INITIAL FIRE SAFETY INSPECTION REPORT

Nkk Knitwear Ltd. (Extension)

RSC ID: 25618

Table-1: 8-Storied RCC New Production Building (Extension) (Building-3)

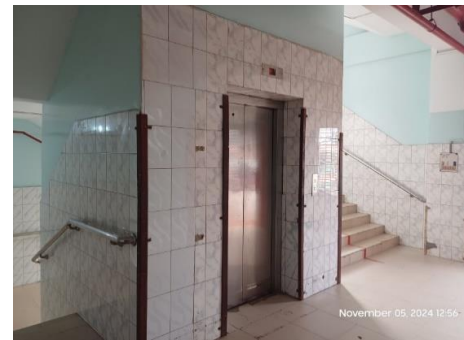
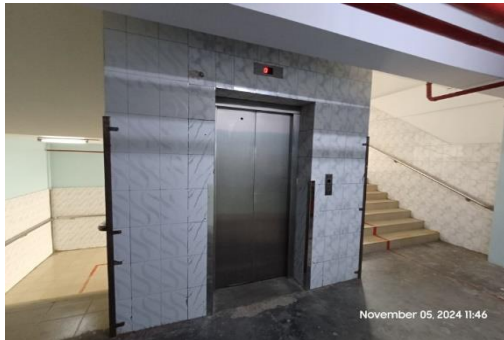
F-02	Fire Rated Construction	<p>Areas used for in-process storage of combustible materials are open to the surrounding occupancy which are not separated by fire rated construction. Location: 6th floor.</p>	<p>Provide dedicated storage rooms separated by minimum 1-hr fire-rated construction. Or, Where separate storage rooms are not feasible, Provide defined storage areas and limit the storage arrangement as follows:-</p> <p>1. General Condition: Maximum height of 2.4m (8 ft) and maximum area of 23 m² (250 sft). Separate areas of unenclosed combustible storage by a minimum clear distance of 3 m (10 ft).</p> <p>2. If sprinkler protected: Maximum height of 3.66 m (12 ft) and maximum area of 93 m² (1000 sft). Separate areas of unenclosed combustible storage by a minimum clear distance of 3 m (10 ft).</p> <p>Note: Do not exceed 10 percent of the building area of the story in which they occur.</p>	Within 3 months

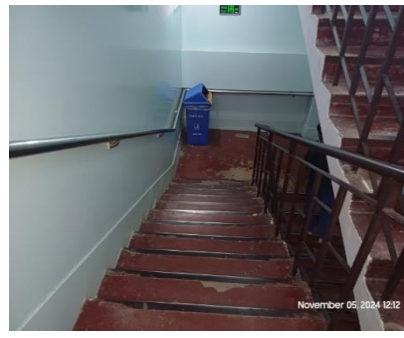
F-03	Fire Rated Construction	<p>Elevator shafts are not separated by fire rated construction from exit stair enclosure on each floors and directly open into inside of the exit stair enclosure. Location: Stair-2.</p>	<p>For new and interim construction, elevators shall not open into an exit enclosure as per RSC Technical Guidelines (Standard) V1.0-6.14.3. So, ensure separate enclosures for the elevator shafts with minimum 2 hr. fire rating. Seal all openings to maintain fire separations.</p> <p>Factory is recommended to follow RSC published "SUPPLEMENTARY PAPER ON REMEDIATION GUIDANCE ELEVATOR OR LIFT SHAFT OPENING IN EXIT ENCLOSURES" for different solutions.</p>	Within 3 months
------	-------------------------	--	--	-----------------
